HARTFORD ZONING BOARD OF ADJUSTMENT

Meeting Notice and Agenda

**Application #01-23 by Catamount Self Storage, LLC
For Conditional Use Approval for a self-storage facility
lot 08-0090-000, Route 14, White River Junction, in an IC zoning district**

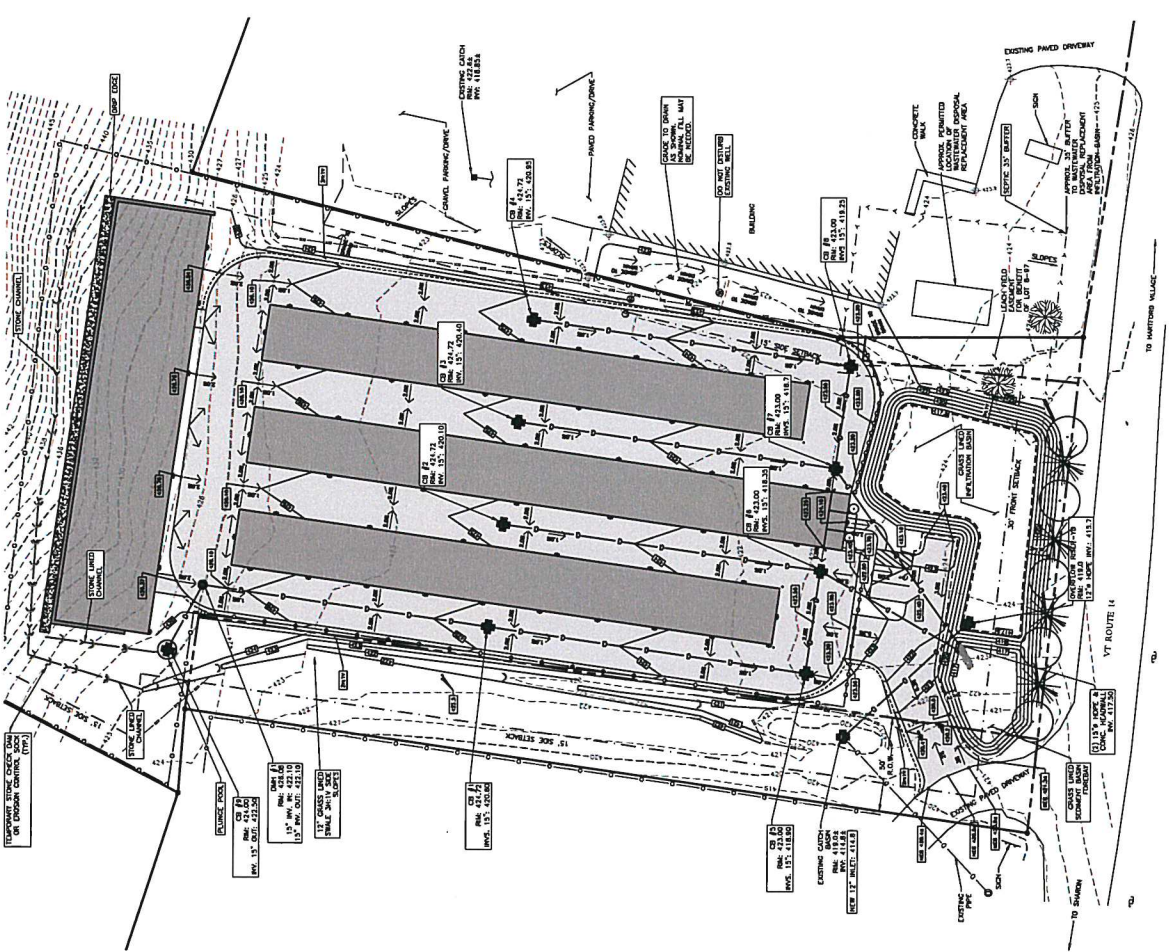
- **A note is added to the existing conditions plan indicating that the 8" PVC drainage pipe shown on the 2005 Hathorn Surveys Plan for Peter L. Jasmin, project #193305 was not found in the field.**
- **The applicant submits a photometric plan for review and approval by the Chair.**
- **The applicant submits a copy of their Access Permit from VTrans.**
- **The applicant submits written verification from the Fire Marshal confirming they have approved the Fire Truck Turning Plan and that they have coordinated emergency access through the gate with the applicant.**
- **The applicant submits a copy of the new State Wastewater Disposal and Potable Water Supply Permit for lot 08-0097-000 (see Finding #15).**

15. A drainpipe is shown running through the lot that is not present on the submitted plans. The plan can be found at:

Please indicate the status of this line, it's location, and use on the plans.

Response: Our field investigations cannot corroborate this concern. If Chris Holzwarth has information material to the application, we welcome his input. AG Self Storage did not encounter anything that corroborates this concern.

LANDSCAPE PLAN FOR
CATAMOUNT SELF STORAGE, LLC
TAX MAP 8, LOT 90
VT ROUTE 14, WHITE RIVER JUNCTION, VERMONT 05001

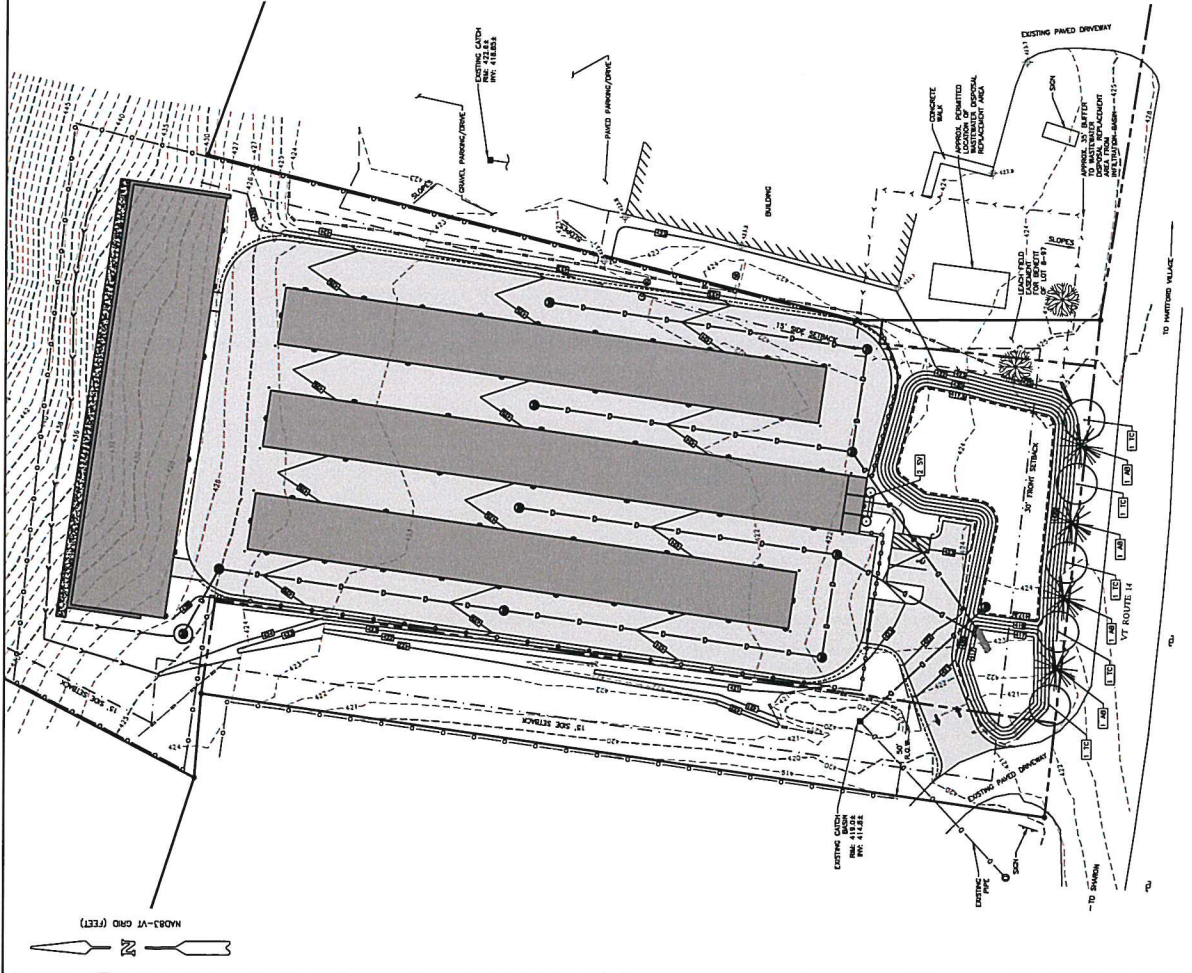
19. Please consider appropriate plantings along the sides and rear of the project and in the stormwater basins.

Response: The Town regulations address road frontage considerations, so we have modified landscape along Route 14 accordingly.

FIRE TRUCK TURNING PLAN B
CATAMOUNT SELF STORAGE, LLC
TAX MAP 8, LOT 90

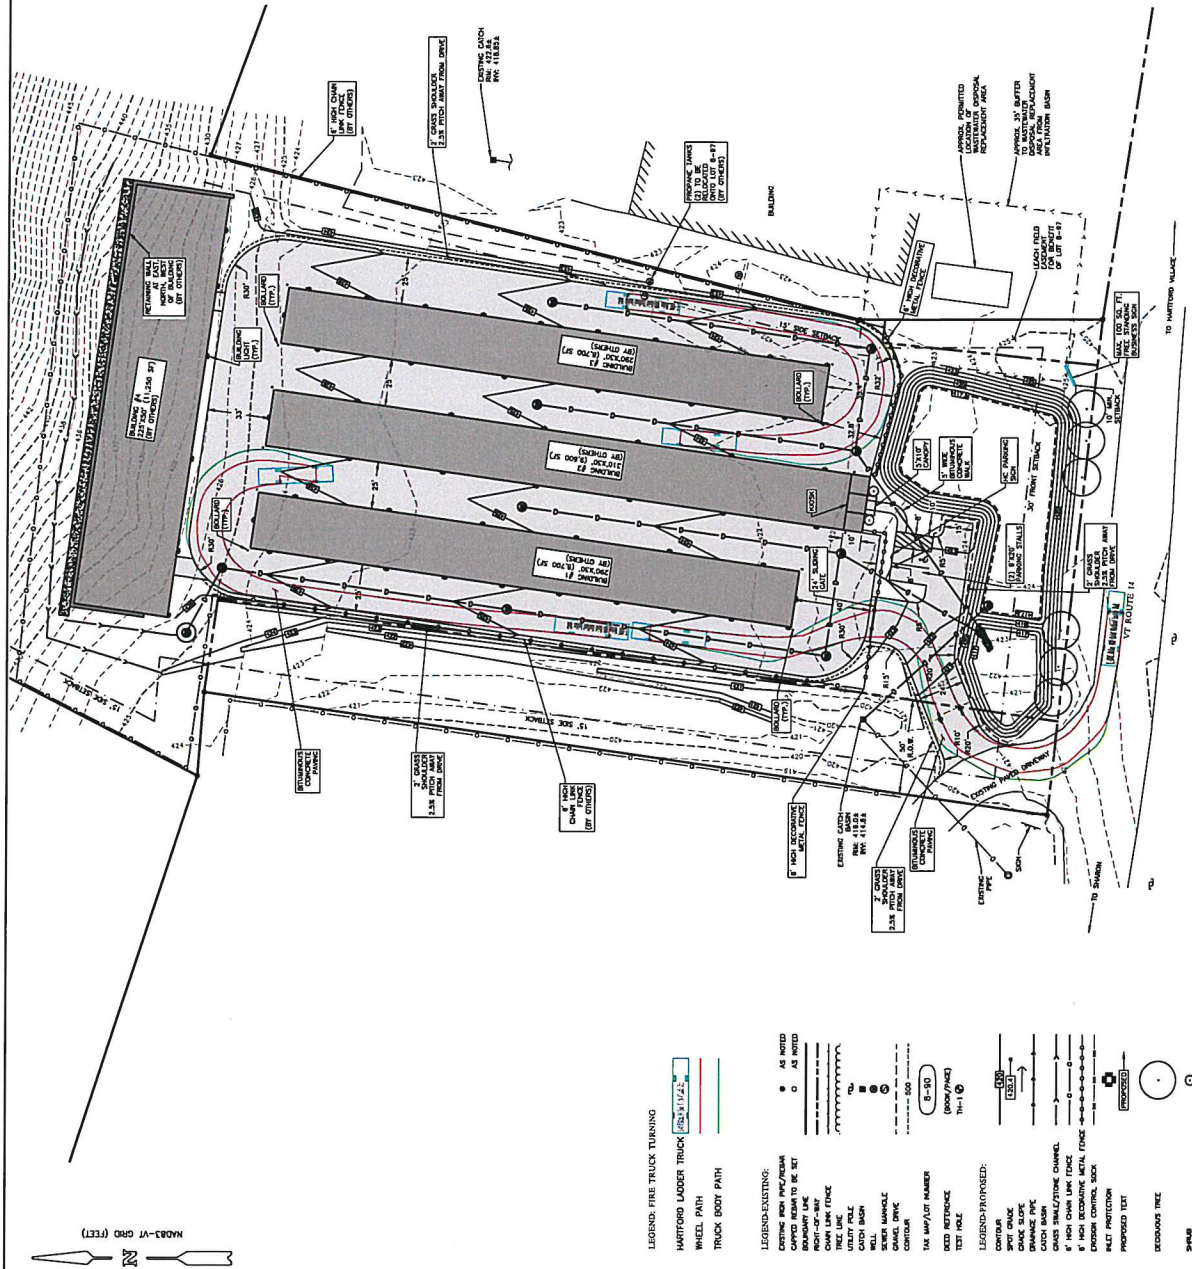
12. Since self-storage facilities are often subject to drop offs and pickups from tractor trailers related to moving companies or commercial renters, please provide a turning movement plan for a tractor trailer.

In addition, the turning plans assume that there will not be a blockage in any aisle. A blockage in any of the easterly aisles will create a dead-end situation without a proper turn-a-round. Please address.

Response: We are not able to make sense of this comment since AG Self Storage and the Apex storage facility recently approved demonstrate the viability of this project.

Response: See previous comment.
